HISTORIC AND DESIGN REVIEW COMMISSION

HDRC CASE NO: 2021-160
COMMON NAME: Multiple Locations in Downtown ROW
ZONING: D, H, RIO
CITY COUNCIL DIST.: 1
DISTRICT: Auditorium Circle Historic District
APPLICANT: Kevin Bowyer/Modus LLC
OWNER: HOTEL HAVANA LLC
TYPE OF WORK: Replace an existing streetlight pole with a new pole with network node equipment
APPLICATION RECEIVED: March 17, 2021
60-DAY REVIEW: Not applicable due to City Council Emergency Orders
CASE MANAGER: Huy Pham

The applicant is requesting a Certificate of Appropriateness for approval to Request to replace existing generic streetlights pole with new streetlight pole with network node equipment in accordance with *CPS Energy: Downtown Street Light Replacement Pilot Program* approved by the HDRC on August 24, 2019

VERIZON SITE ID:
SADT_RIVERWALK_NAVARRO_SC

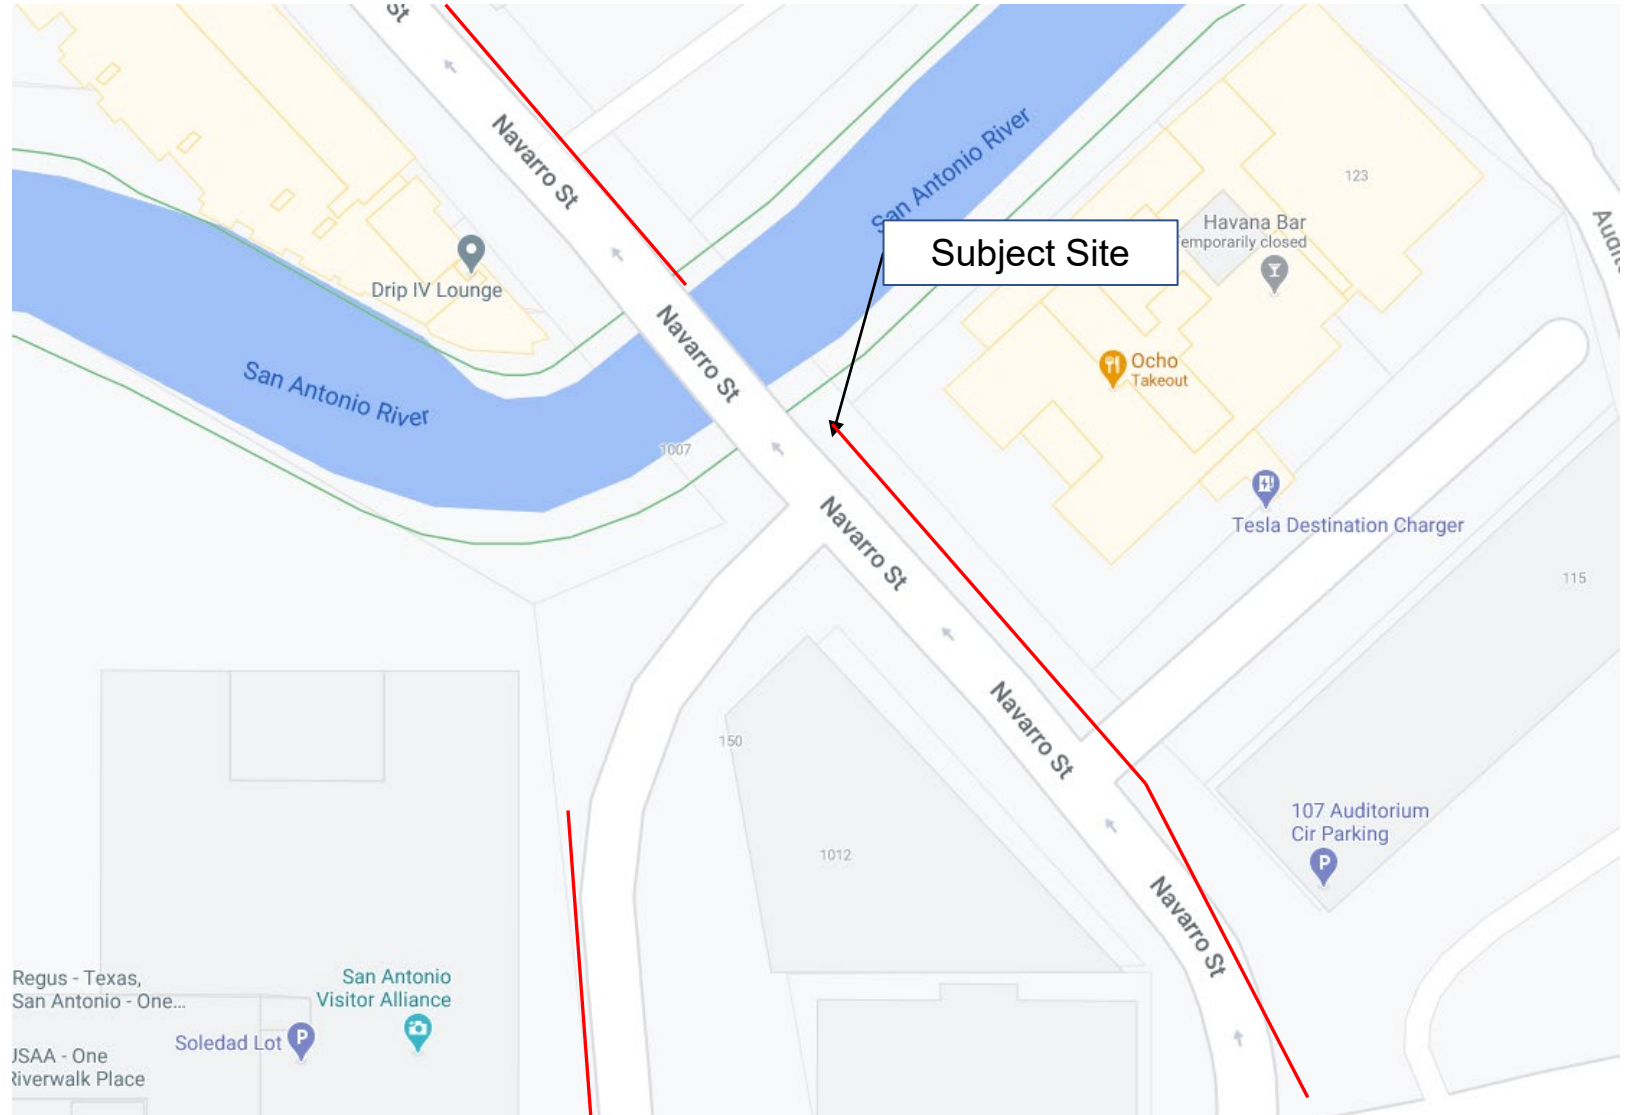
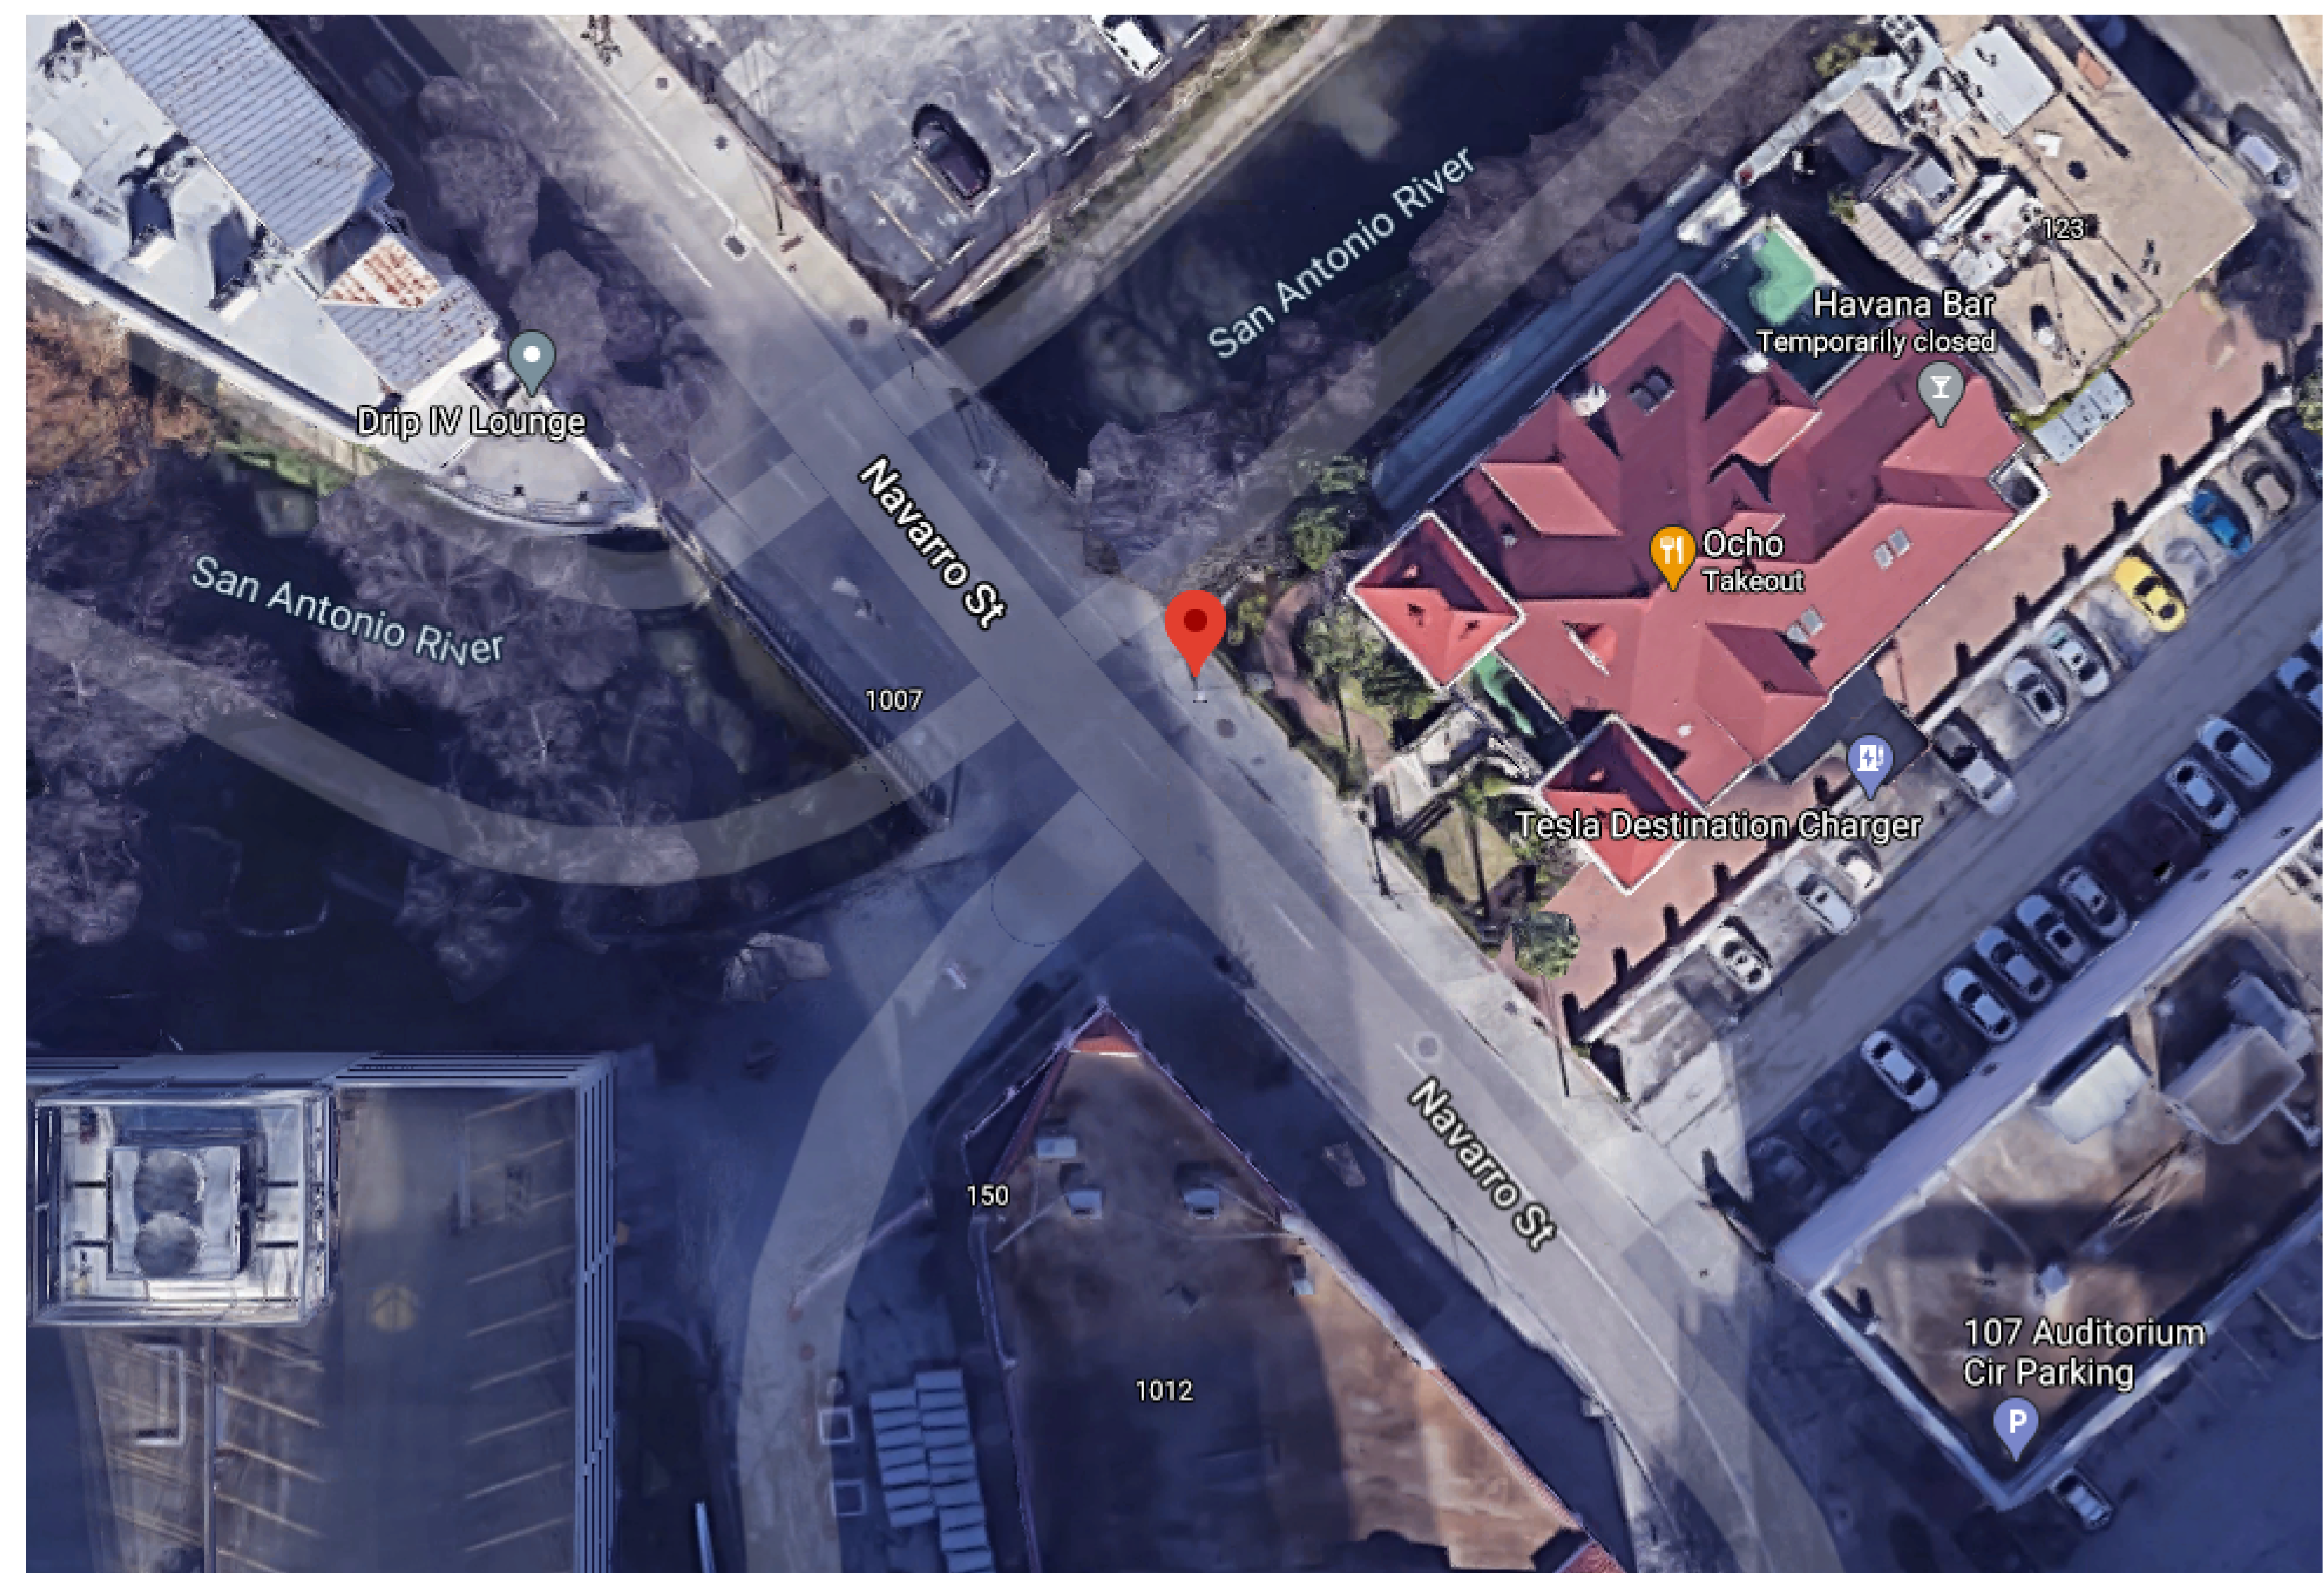
- d. **Pole 2 - ROW near 1017 Navarro - SADT RIVERWALK NAVARRO SC # 2020-19133 -** The applicant has proposed to replace the existing generic streetlight pole with a new streetlight pole with network node equipment at the right-of-way near 1017 Navarro at (29.430763, -98.490099). The proposed pole is located within RIO-3, Auditorium Circle Historic District, and surrounded by 2 individual landmarks. Staff finds that the proposed location is placed at the corner of the nearby historic structure, does not bisect historic facades, and does not detract from the pedestrian experience.

Staff recommends approval of item 1 through 14 based on the findings. All stipulations from the *Pilot Program* and final product design continues to apply.

VERIZON SITE ID:
SADT_TOBIN_NW_SC

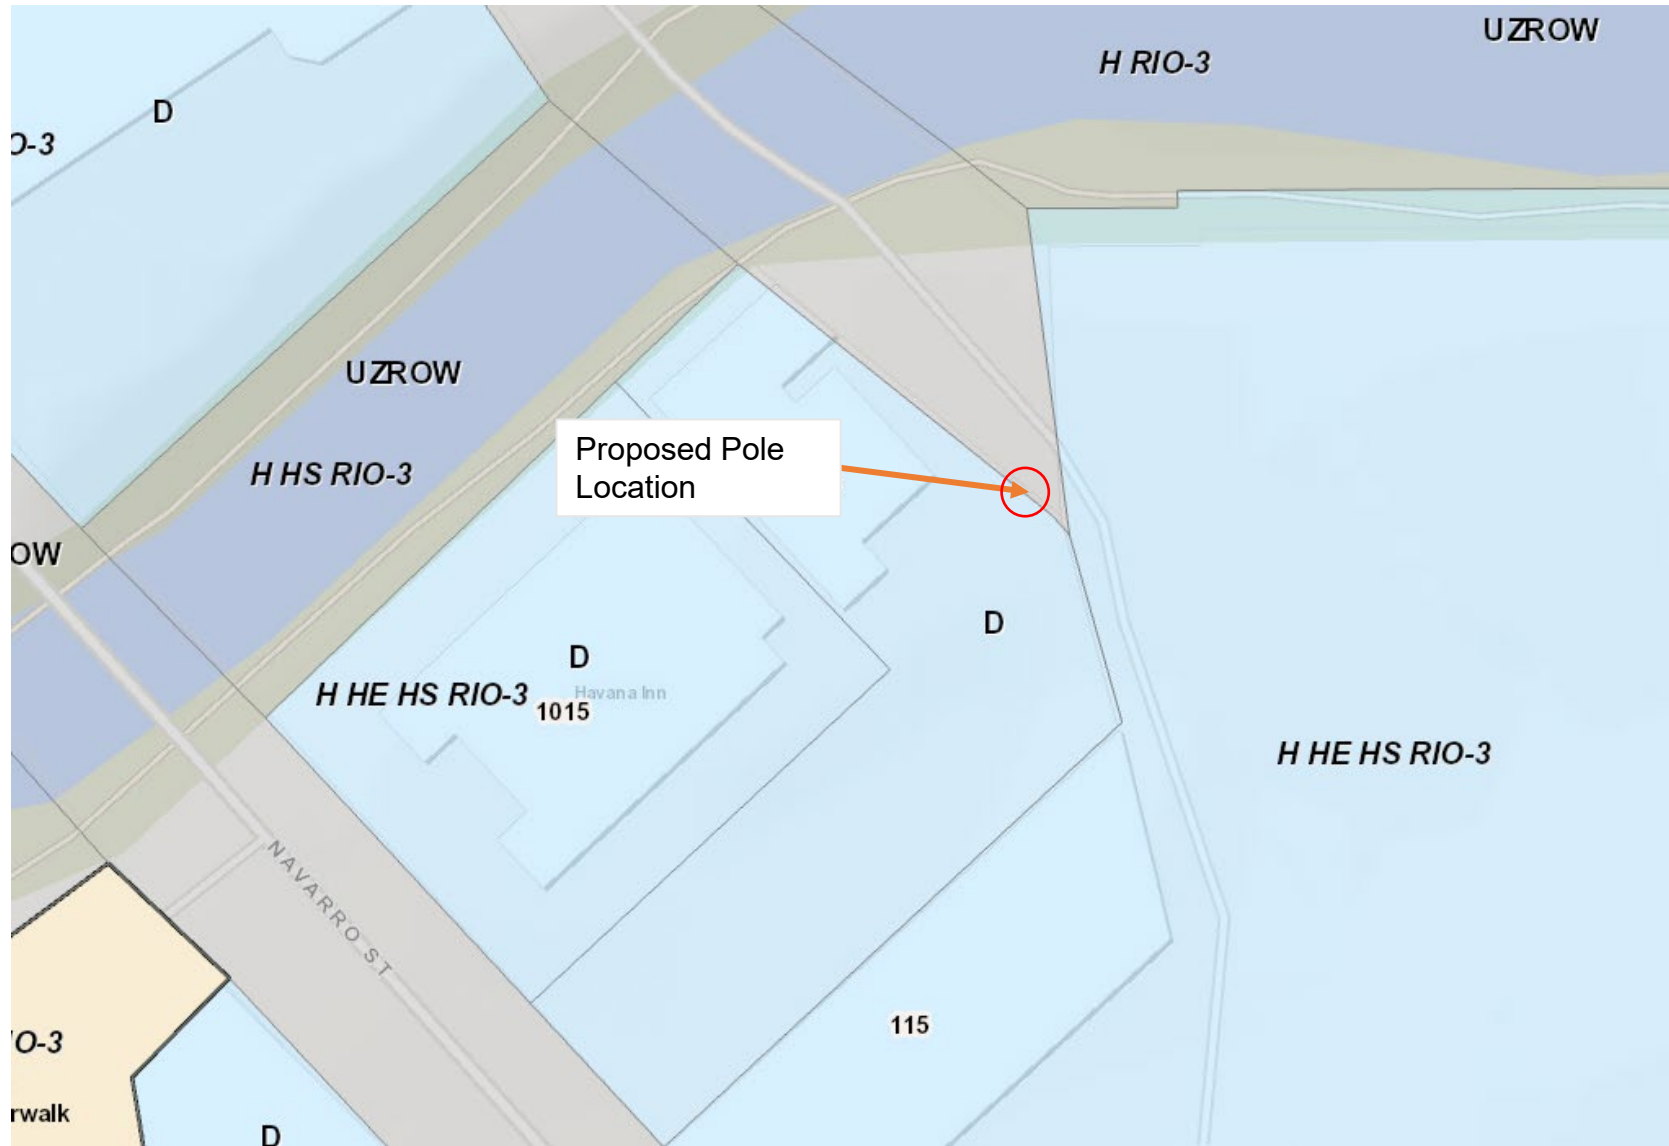
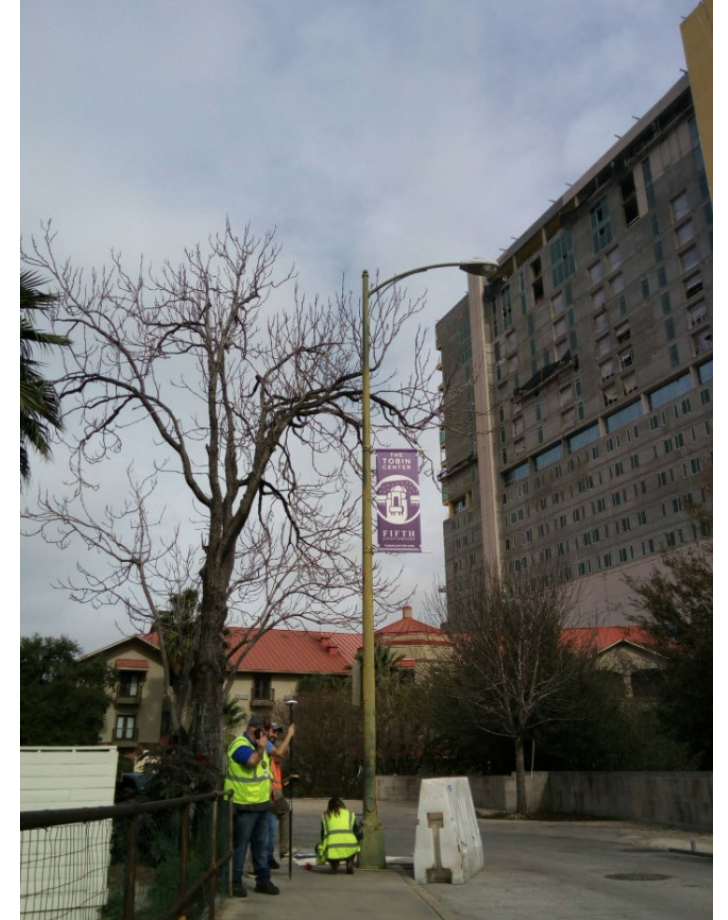
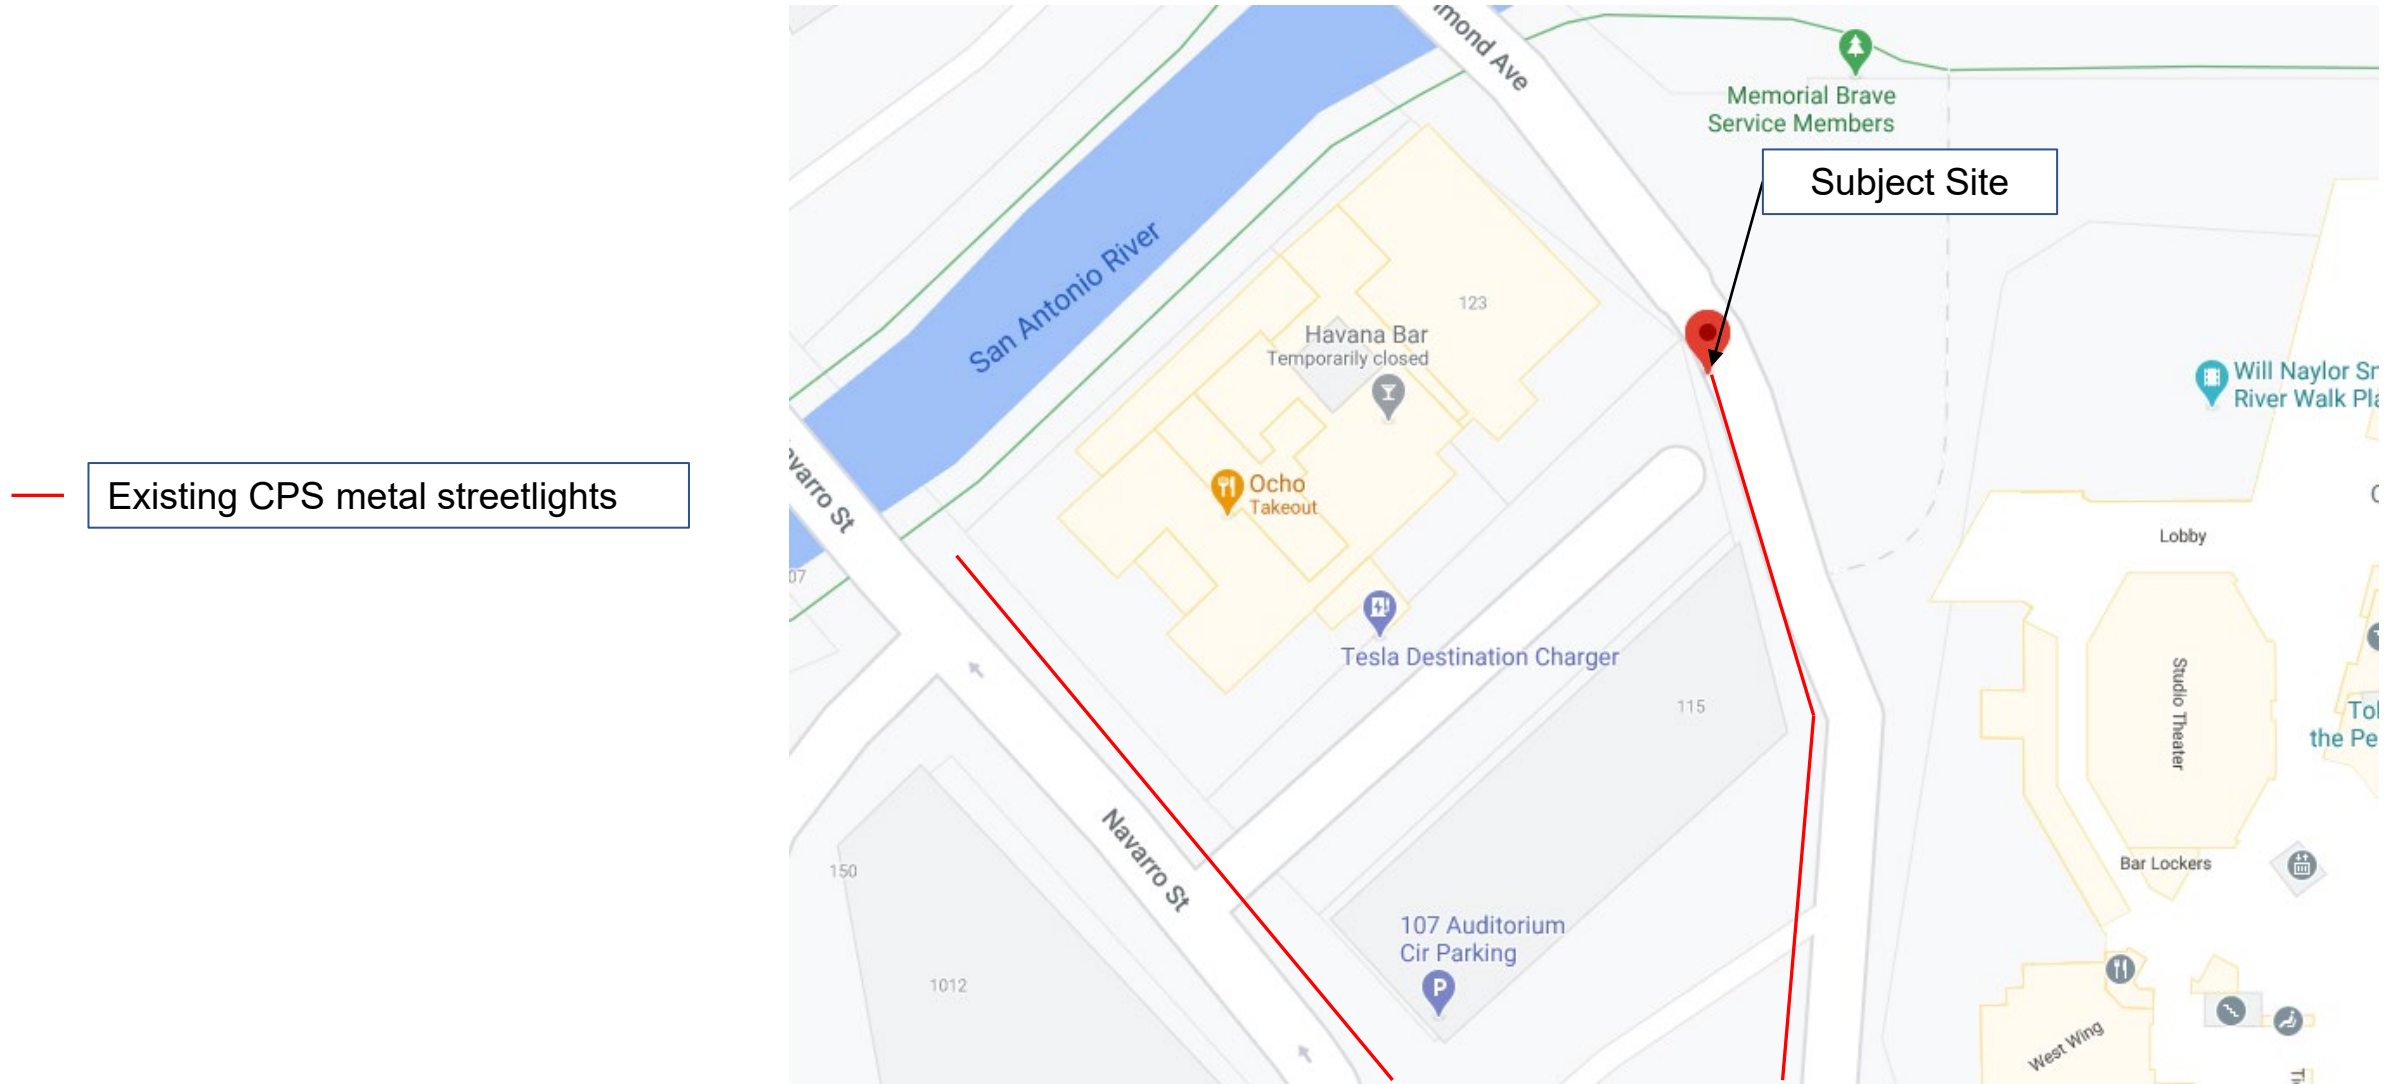
- c. **Pole 1 - ROW near 123 Auditorium Cir - SADT TOBIN NW SC # 2021-21087 -** The applicant has proposed to replace the existing generic streetlight pole with a new streetlight pole with network node equipment at the right-of-way near 123 Auditorium Cir at (29.430914, -98.489419). The proposed pole is located within RIO-3, Auditorium Circle Historic District, and surrounded by 3 individual landmarks. Staff finds that the proposed location is adjacent to a parking lot and to the side and rear of the surrounding historic features and does not detract from the pedestrian experience.
